Amendments to the Drawings

REMARKS

In response to the Office Action mailed January 5, 2005, Applicant submits the following amendments and remarks. Claims 7-17 were previously pending in this application (claims 1-6 having been withdrawn from consideration). By this amendment, Applicant is amending claims 7, 9, 12 and 13, canceling claim 10 and adding new claims 18-30. As a result, claims 7-9 and 11-30 are pending for examination with claims 7, 9, 12, 15, 18, 21 and 29 being independent claims. No new matter has been added and the application as presented is believed to be in condition for allowance.

FIG. 1

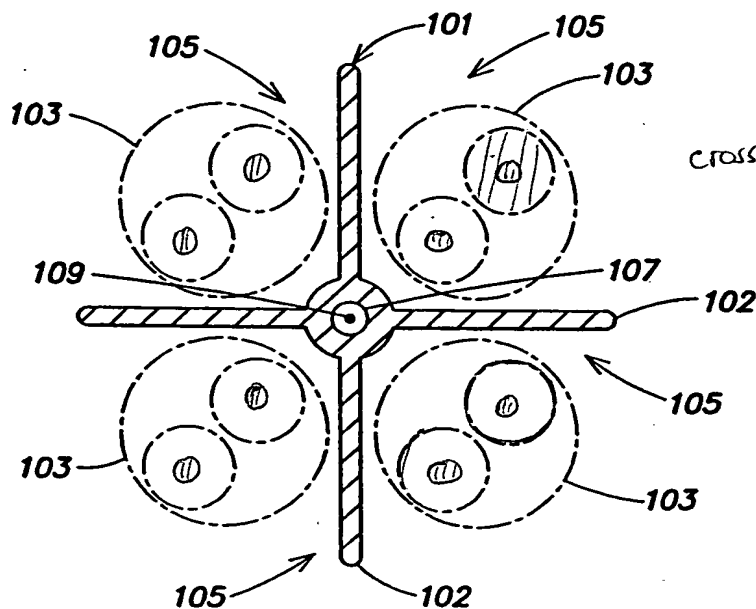
Applicant thanks the Examiner for conducting a telephone interview with Applicant's representative's assistant on May 2, 2005 to discuss the drawings. During the interview, the Examiner explained that Figures 1, 3, 4, 9B, 11 and 13 were objected because the twisted pairs of insulated conductors (and in Figs. 11 and 13, also the core and the jacket) are shown without proper cross-hatching. Applicant believes that the drawings were compliant with the twisted pairs shown in phantom lines in Figs. 1, 3, 4 and 9B because the focus of the drawings was not on the twisted pairs and the intent was to show the twisted pairs in phantom. However, Applicant's representative's assistant agreed to make the necessary changes to the drawings to overcome the Examiner's objection.

The Examiner has objected to Figures 1, 3, 4, 9B, 11 and 13 as lacking proper cross-hatching. Applicant has amended the drawings to include proper cross-hatching as requested by the Examiner. Accordingly, withdrawal of the objection to the drawings is respectfully requested. Marked-up copies of the amended figures are attached as annotated sheets 1-5.

Applicant has amended Figures 1, 3, 4, 9B, 11 and 13 to overcome the Examiner's objection to the drawings. The amendments are shown in red on Annotated Sheets 1-5 attached hereto. The amended Figures are attached as Replacement Drawing Sheets 1-5. Entry and approval of these replacement figures is respectfully requested.
